Docket Item # 9  
BAR CASE # 2010-0047

BAR Meeting  
April 21, 2010

**ISSUE:** Demolition/Encapsulation  
**APPLICANT:** Alexander St Clair & Julia Egy  
**LOCATION:** 404 Jefferson Street  
**ZONE:** RM Residential

**BAR CASE #2010-0047, 0048 4/21/2010**

Figure 1. Plat.

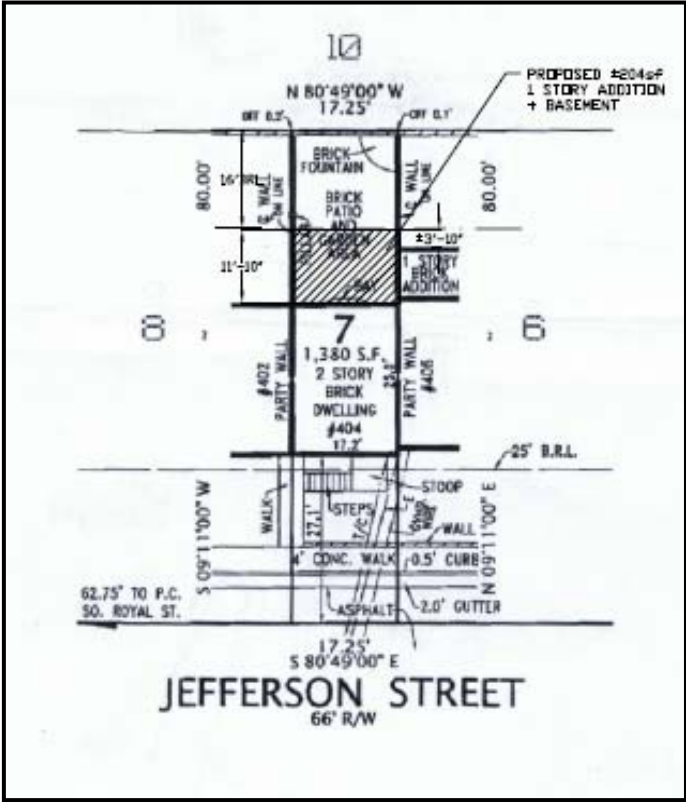
The applicant is requesting approval of a Permit to Demolish/Encapsulate in order to construct a rear addition at 404 Jefferson Street. The proposed addition will consist of an 11 foot ten inch extension of the entire 17 foot 2 inch width of the basement and first stories of the home for a total proposed area of encapsulation of 354 square feet. The demolition will constitute the loss of a wall on the basement level containing a French door, and a wall on the first floor containing a large bow window.

In the opinion of Staff, none of the criteria are met. The area of proposed encapsulation impacts the rear of the house which is not visible from the public right of way. The rear of this mid-20<sup>th</sup> century building lacks architectural detail of unusual or uncommon design and could be easily reproduced today. Staff, therefore, recommends approval of the Permit to Demolish/Encapsulate.
